APPLICATION NO.	FILING DATE	FIRST NAMED INVENTOR	ATTORNEY DOCKET NO.	CONFIRMATION NO.
10/628,266	07/29/2003	Arthur Croft	2123-Util	4717

Office Action Summary

DETAILED ACTION
Specification

Fig. 11

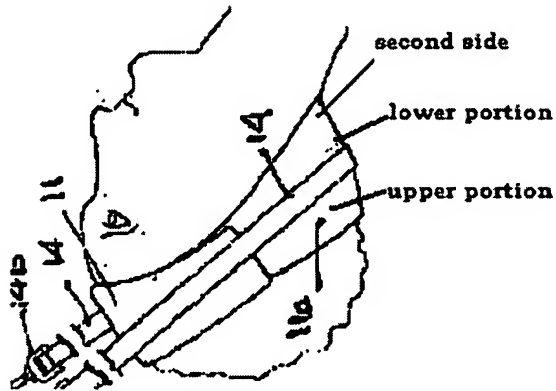
3. **As to claim 2, Goodley** additionally discloses headpiece includes a first side and a second side, the first loop connected to the second side (see labeled fig.11).

4. **As to claim 3, Goodley** discloses the second side of the headpiece having an upper portion, a lower portion, a right side and a left side, wherein the majority of the first loop is generally attached about the second side of the lower portion (see labeled fig.11).

6. **As to claim 5, Goodley** discloses a strap adapted to be placed about the forehead of a person, said strap has a front side, a back side, a right side and a left side, said strap said back side resides on the forehead of said person (see fig.11, reference object 11).
